ENGINEERING CHANGE NOTICE

1. ECN 167534

Proj. ECN B-714-134

3. Originator's Name, Organization, MSIN, and Telephone No. T. E. Coyne, KEH, E6-42, 6-2564			4. Date 07-13-92	
5. Project Title/No./Work Order No. Grouted Waste Disposal Facilities, B-714/ER8007		6. Bldg./Sys./Fac. No. 218-E-16		7. Impact Level 3Q /SC-2

Page
5/10

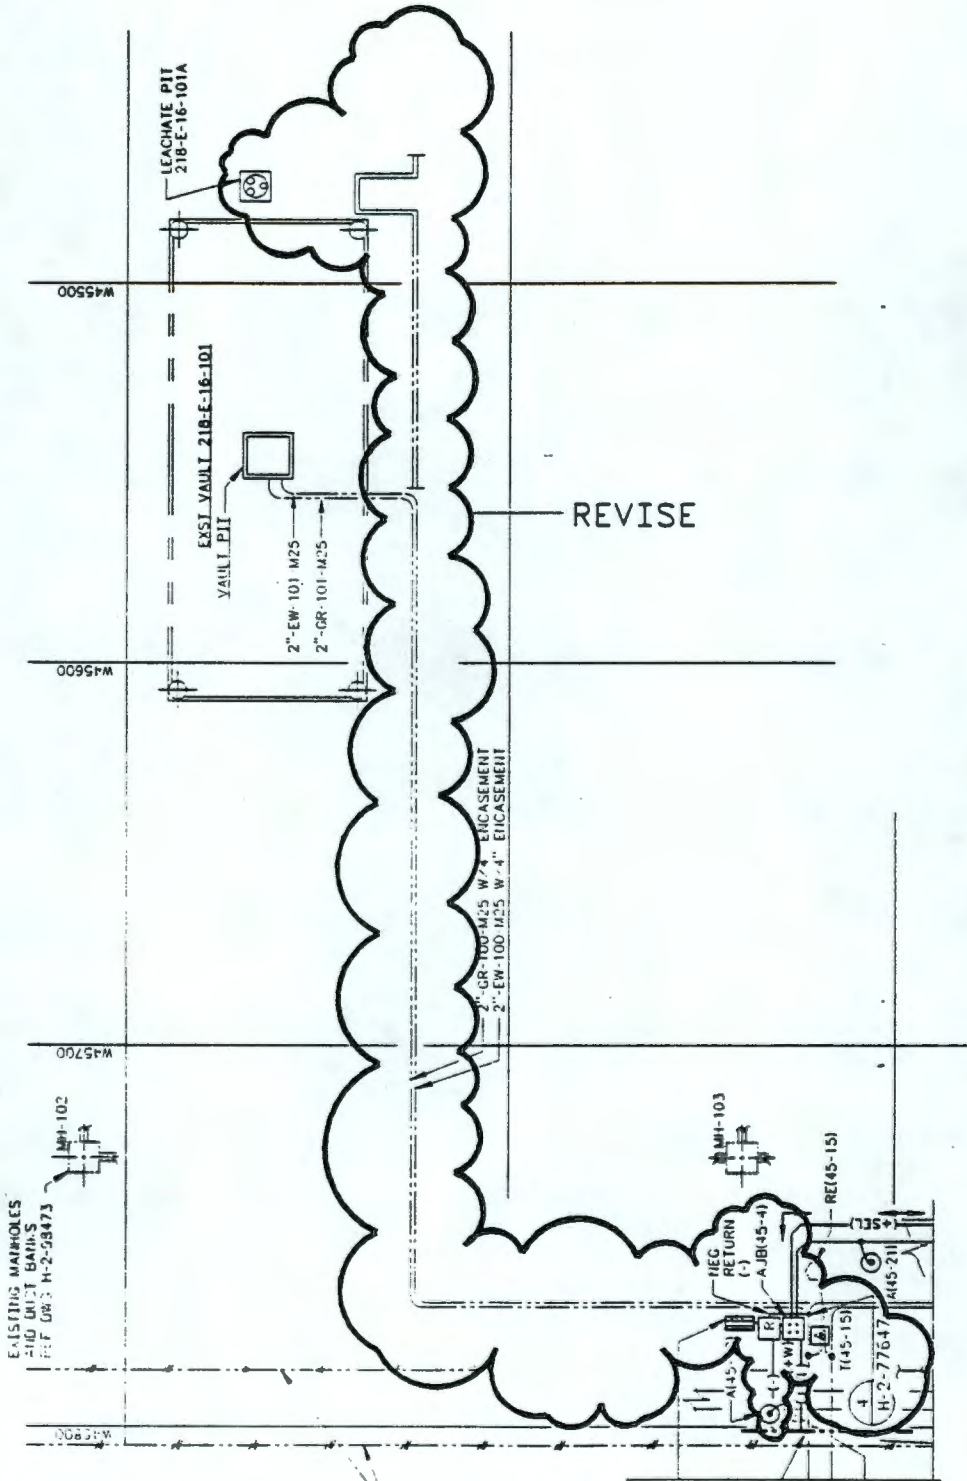
- 1) H-2-77645, Sh 1, Rev 1
- A) Plan: Delete the cathodic protection system between Anode Junction Box AJB(45-4) and Vault 101 & revise plan as shown on page 5 of this ECN.

Page
6/10

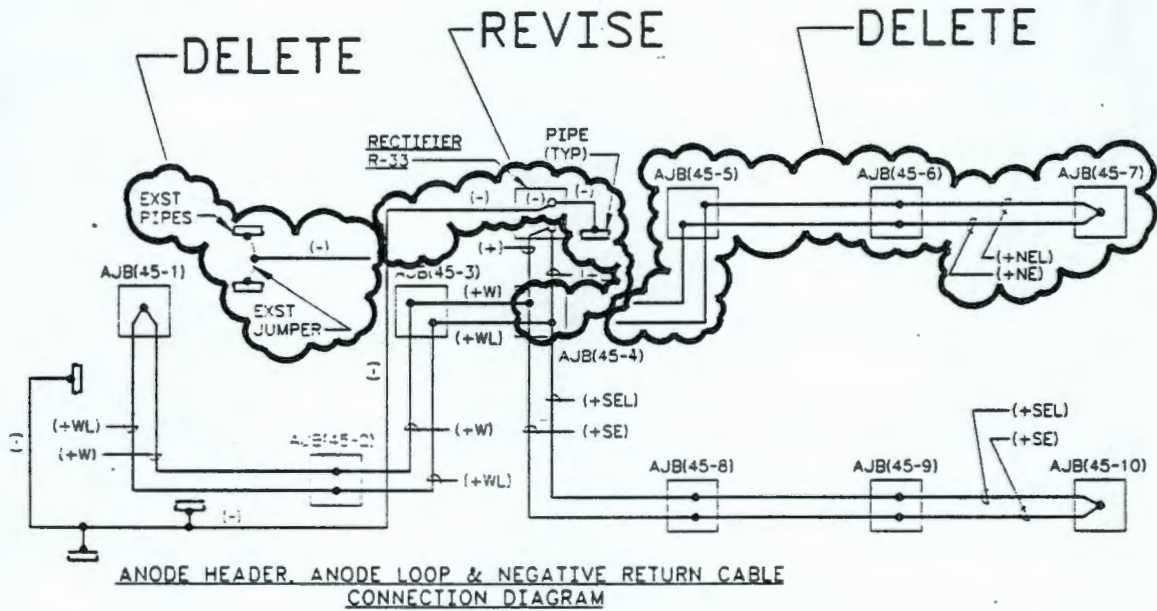
- B) Connection Diagram: Modify as shown on page 6 of this ECN.
- C) Anode Location Table:
- Delete the following anodes and corresponding coordinates: A(45-11), A(45-12), A(45-13), A(45-14), A(45-15), A(45-16), A(45-17), A(45-18), A(45-19), A(45-20), & A(45-34).

Kaiser Engineers HANFORD		ENGINEERING CHANGE NOTICE SKETCH	
Ref. Dwg. H-2-77645	Sh. 2	Rev. 1	Prepared By TE COYNE
Checked By <i>G.M. D... D</i>		ECN No. B-714-134	
Page 7/10

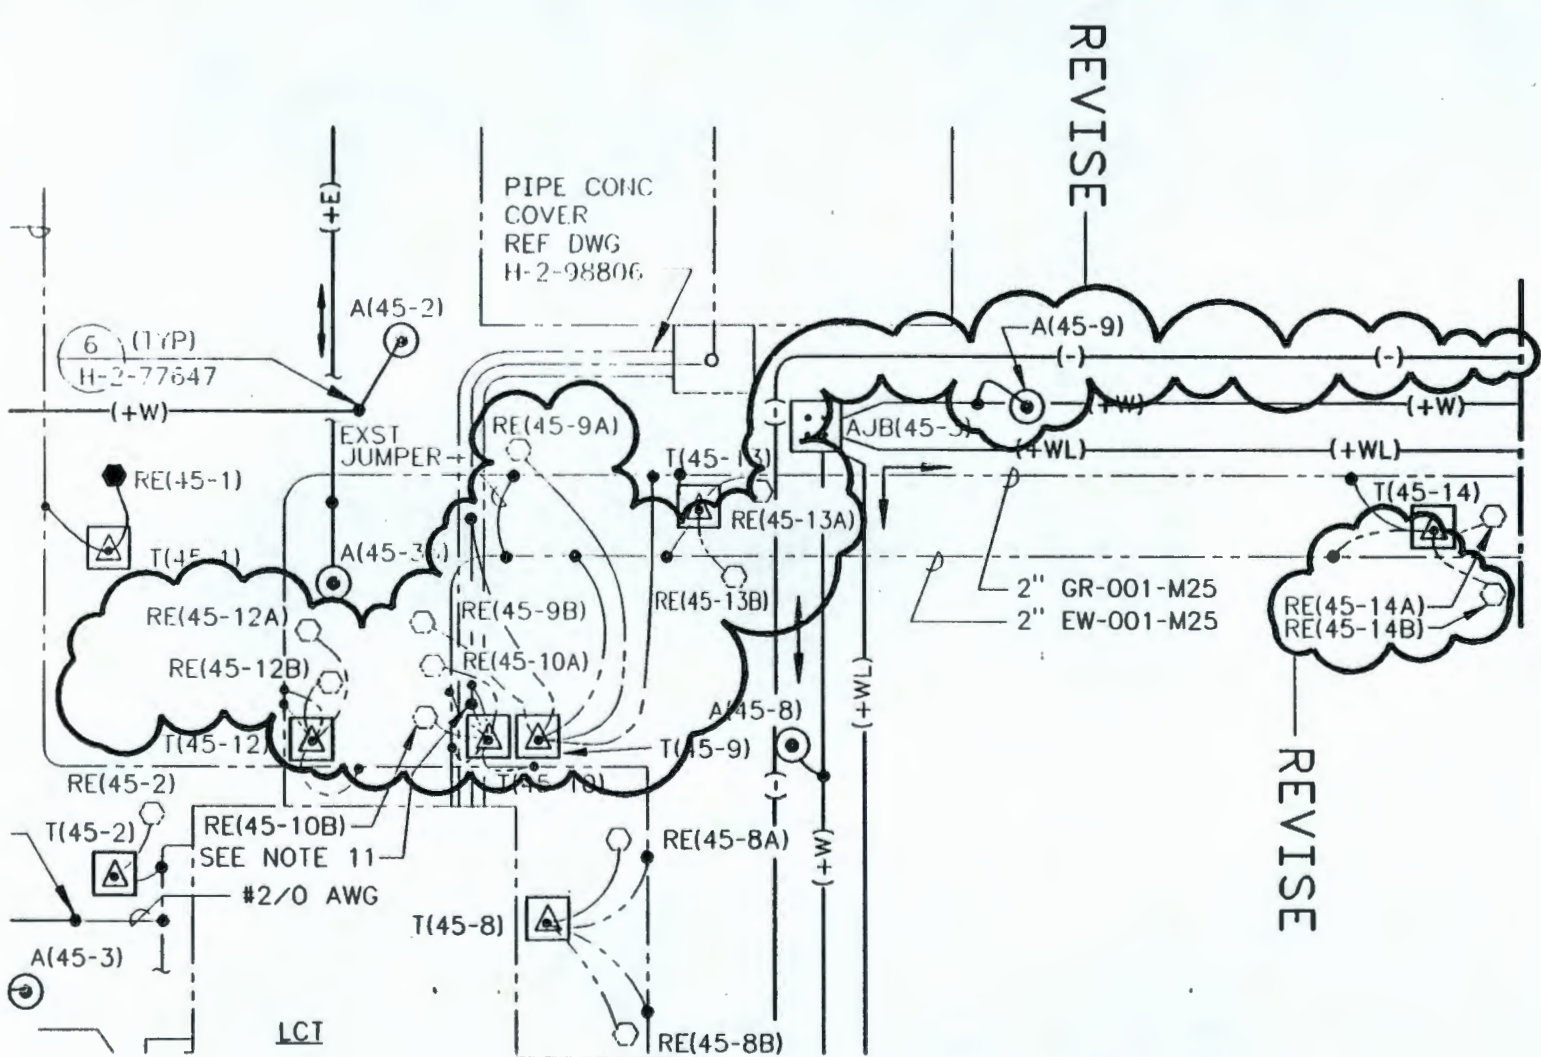
- 2) H-2-77645, Sh 2, Rev 1
- A) Plan (Z D6-7 & B6-7): Modify as shown on pages 7 & 8 of this ECN.
- B) Table: Modify as shown on page 10 of this ECN.

Page
9/10

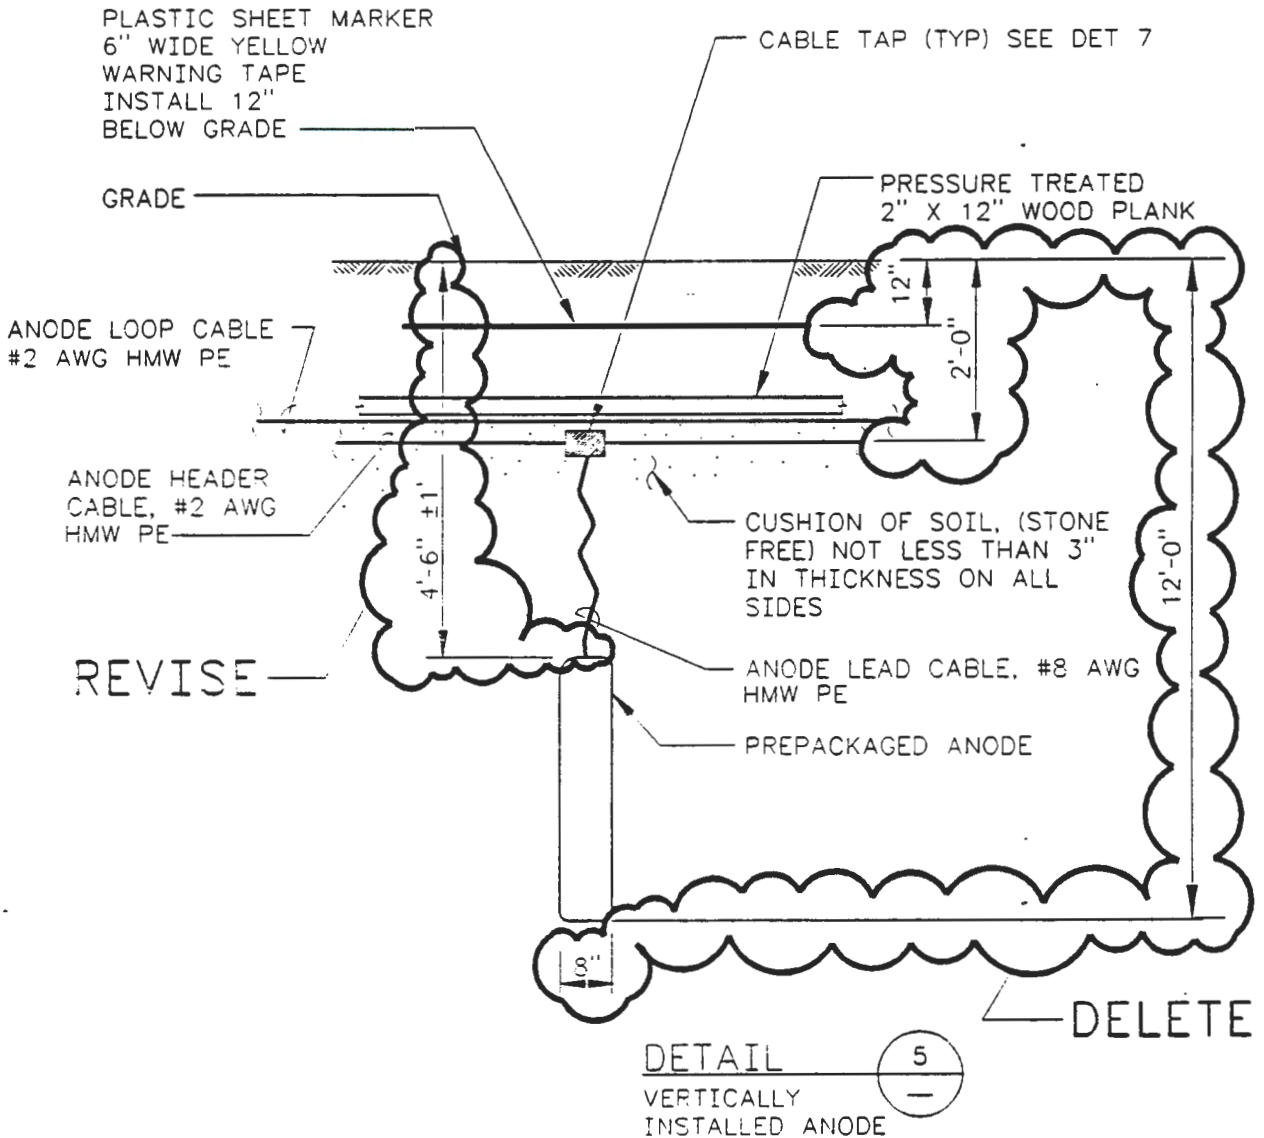
Detail 5 (Z C7-D8): Modify as shown on page 9 of this ECN.
